ENGINE – MAIN GEARBOX ASSEMBLY TO INTRODUCE GEARBOX CASING AND IDG ADAPTER DRAWINGS
WITH REVISED DIMENSIONS FOR A1 AND A5 MODELS – CATEGORY CODE 7 – MOD.ENG-72-0153

V2500-ENG-72-0153

SERVICE BULLETIN

Housing IDG - Drive
Fig.1

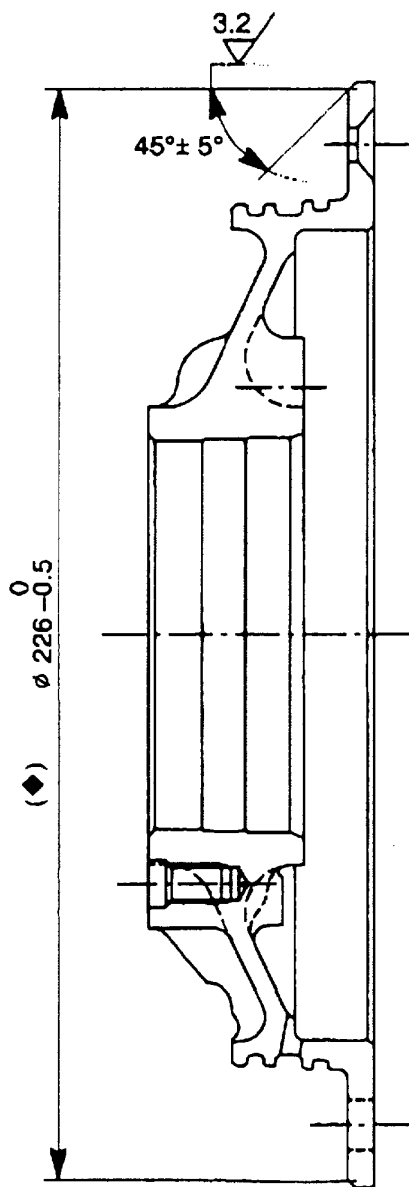
Rework 4B0281 Housing assembly of IDG and reidentify as follows:

- (1) Rework the chamfer in order to obtain the new dimensions (

See Figure 1

- (2) Renumber 4B0312 adjacent to existing part number. Delete 4B0281 with a single line

Casing, assembly of, Gearbox
Fig.2

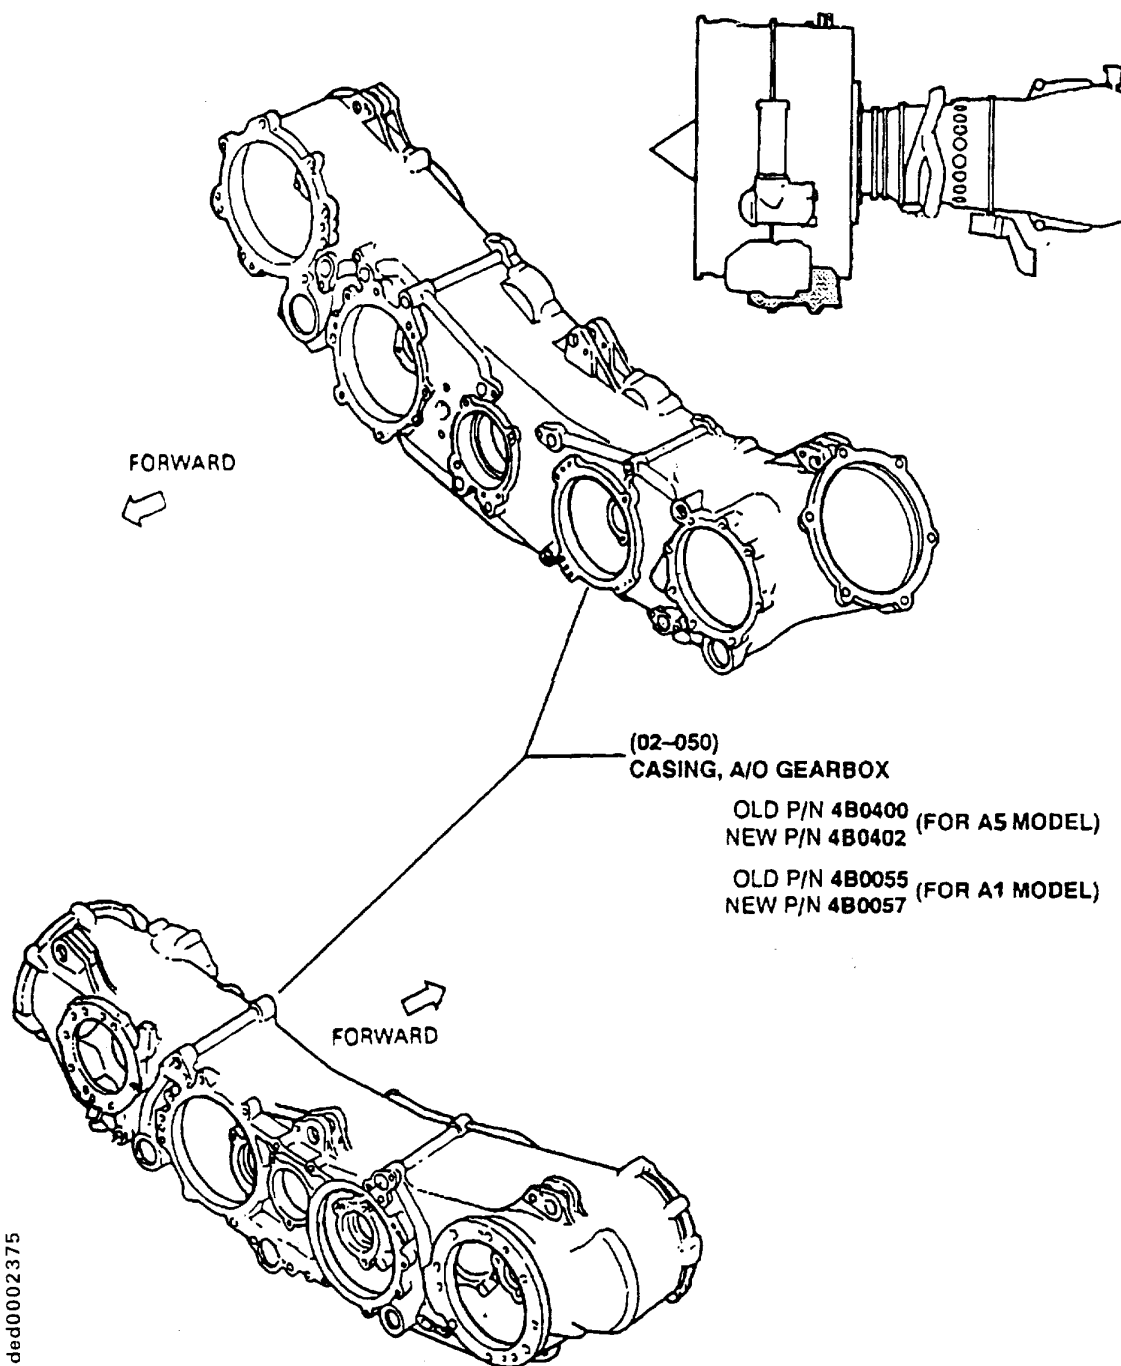
- (1) V2500 Engine Illustrated Parts Catalog (IPC) (S-V2500-1IA and S-V2500-2IA), Chapter/Section 72-60-21 and 72-60-28 will be changed to add new part numbers (See Figure 2 and 3).
- (2) V2500 Engine Manual (E-V2500-1IA), Chapter/Section 72-60-28, Cleaning, Inspection, Repair, to extend the procedure to the new housing part number.
